Staff Report - Certificate of Appropriateness Application

Knoxville Historic Zoning Commission

File Number: 3-G-20-HZ

PROPERTY LOCATION: 0 N. 3rd Ave. / Parcel ID 81 M K 017

SITE PLAN

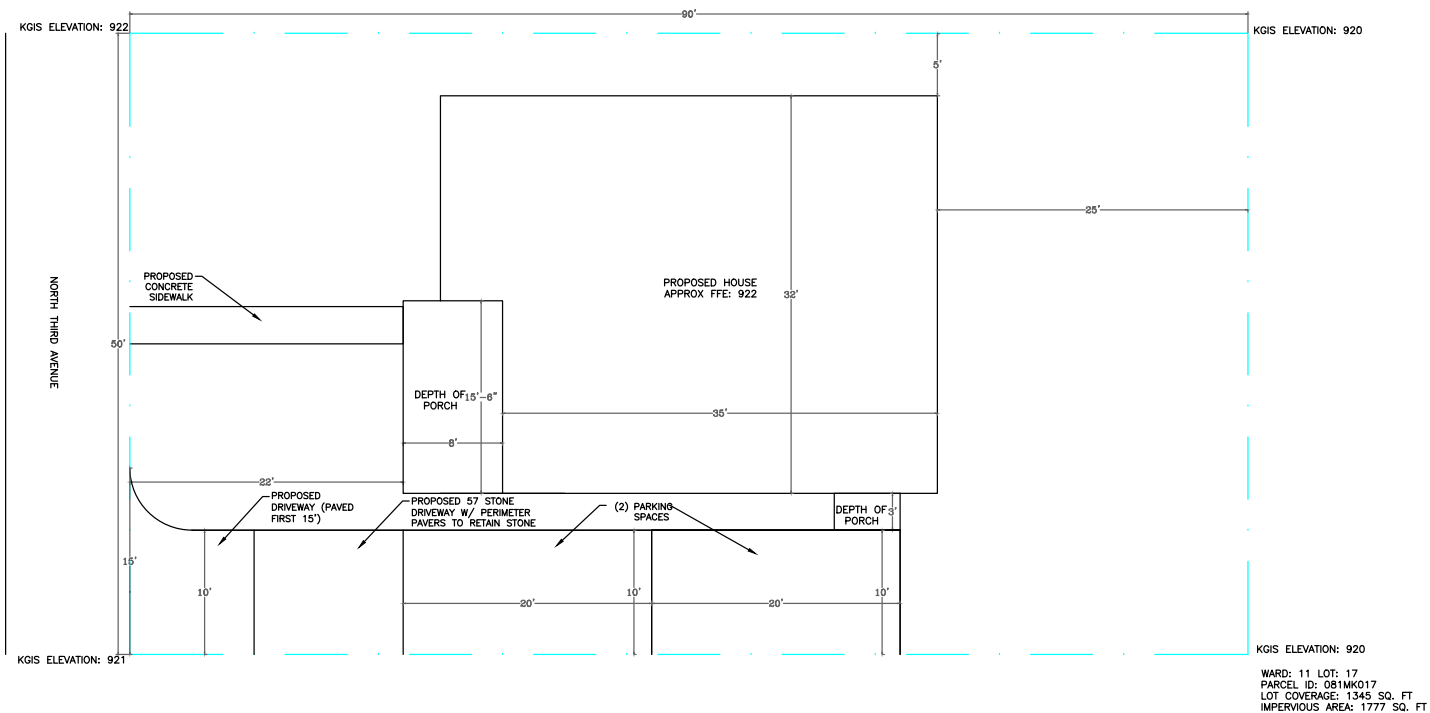
1. The proposed house will establish a new front setback pattern for the block. It cannot draw precedent from the other house fronting N. 3rd Avenue, as that house predates the construction of I-40 and historically fronted 4th Avenue. The house must meet the setback requirements of the base zoning for RN-2, which is a front setback of at least 20' (or the average of the blockface) and a rear setback of 25'. Establishing a modest front setback of 22' will ensure that future construction on any of the viable lots on N. 3rd Avenue will not conflict with the base zoning. Moreover, they will be somewhat less visible from surrounding streets, especially as the rear property line is flanked by a tall concrete sound wall.

FRONT ELEVATION

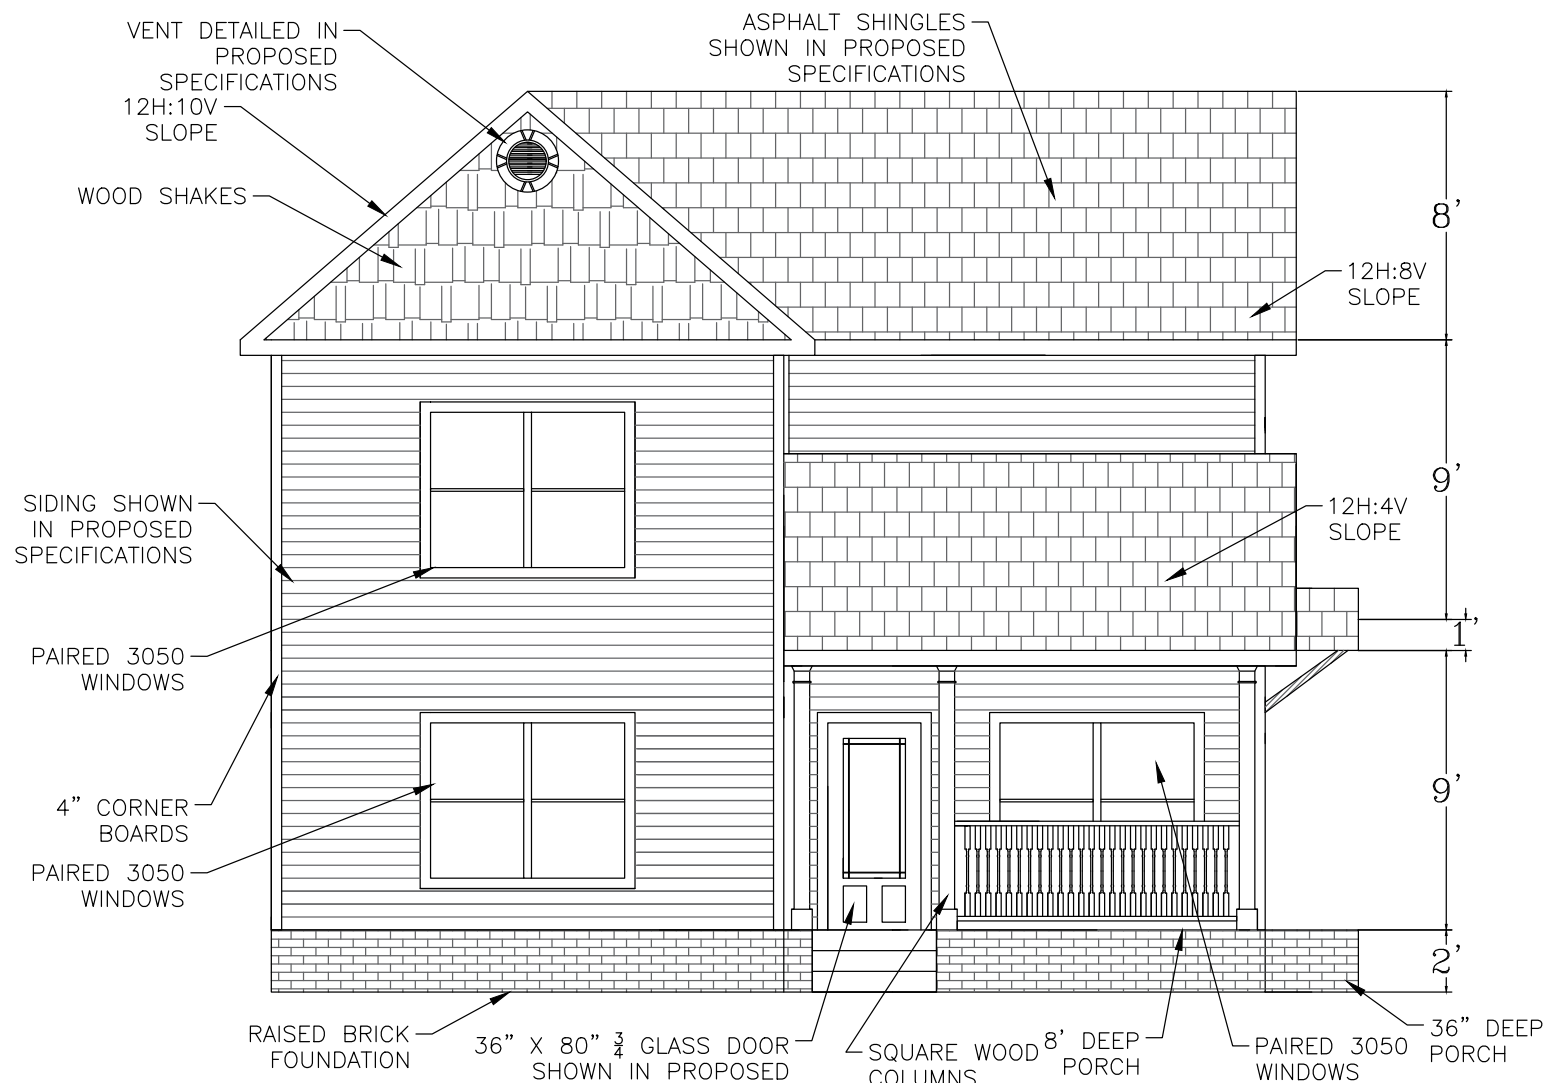
6. While a one-story porch on a two-story house is an appropriate element for the selected house form, both the length and the pitch of the shed roof on the front porch are disproportionate on the façade and right elevation.

The 4/10- pitch shed roof on the front porch has to extend too far towards the rear to connect with the side-gable roof massing, and attempts to accommodate additional interior space below. Precedent houses included in the application packet show houses with hipped roofs with front gable massings projecting from the façade. On the precedent houses, this creates an L-shape plan where the porch roof extends directly to the recessed exterior wall of the hipped-roof massing, instead of creating one story of additional space below the porch roof.

Moreover, the precedent houses all have shallow, lower-pitched hipped roofs which allow for space for second-story windows on the façade above the porches.

7. While simple one-over-one windows are appropriate for new construction in the neighborhood, depictions of the windows in the provided elevations don't necessarily reflect the thickness of the actual meeting rail between the two window sashes. Vinyl is not an appropriate material for windows in the neighborhood. Moreover, the paired 3050 windows in the specifications should be separated by appropriate trim to resemble two separate windows instead of factory-joined windows. Due to the somewhat smaller height of the house (compared to other houses shown as precedent), the 3050 windows seem slightly disproportionately large. The 1550 windows on the rear and side elevations appear disproportionately narrow. Header heights of the windows should be consistent around the house. Window sills should also be included.

9. The façade has a strong sense of entry as recommended in the guidelines. A 3/4-light door is an appropriate design for the context.

- 1) elevation drawings to reflect fascia boards and eave overhangs on the house;
- 2) applicant to select different window material and window sizes more proportionate for the size of the house and the neighborhood context, and updated drawings to show appropriate 4" window trim and window sills, with a consistent window header height on sides and rear elevations;
- 3) re-design of front porch and right elevation;
- 4) relevant guidance from the neighborhood to be incorporated.

RIGHT ELEVATION

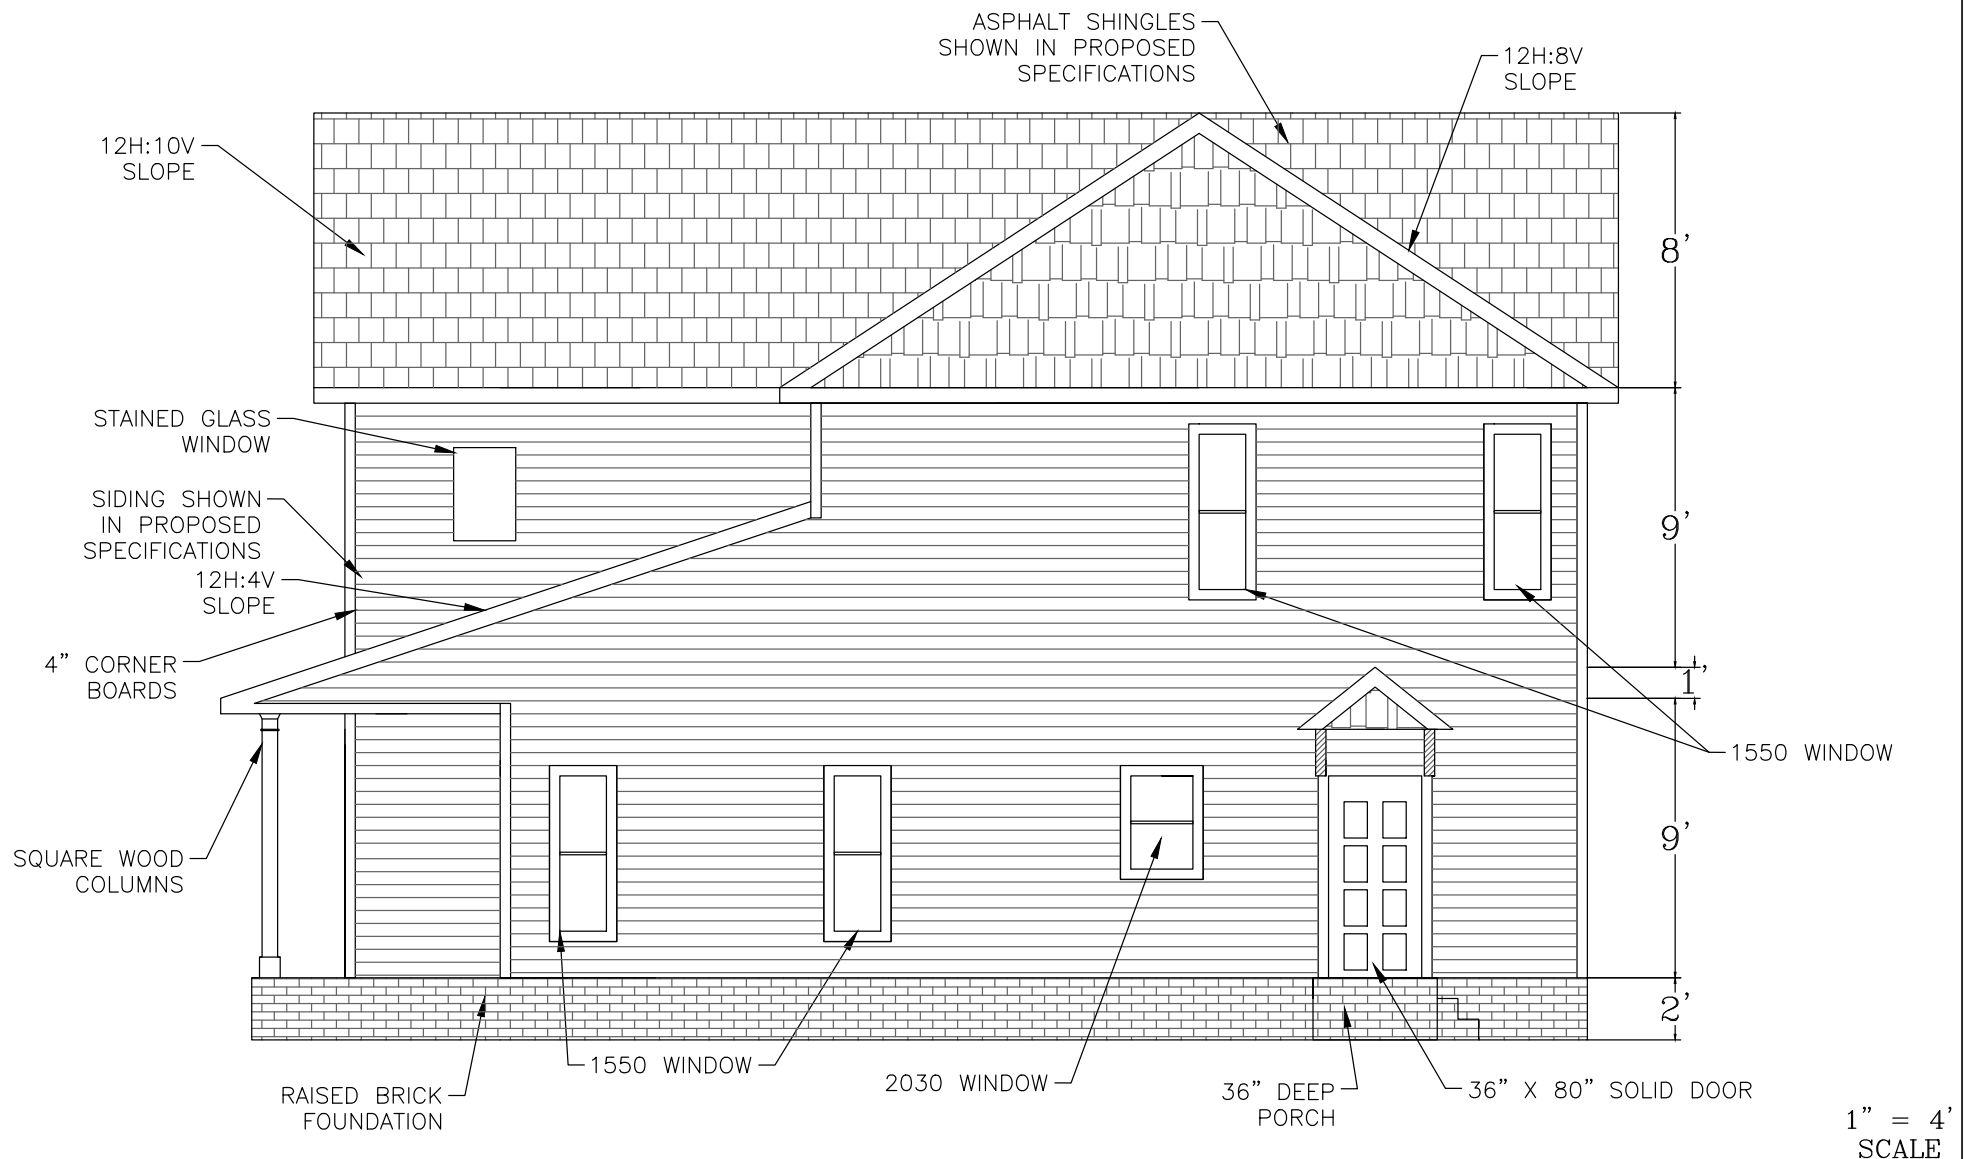
10. The simple gable-roof stoop is an appropriate form for a secondary entry porch. However, the gable roof should be set 1'-2' lower on the elevation so the bottom of the gable is better aligned with the actual door. The gable is also too narrow for the door. The door selected for the secondary entry is compatible in size, scale, and materials with the house and the primary entrance and does not have the appearance of a primary entry.
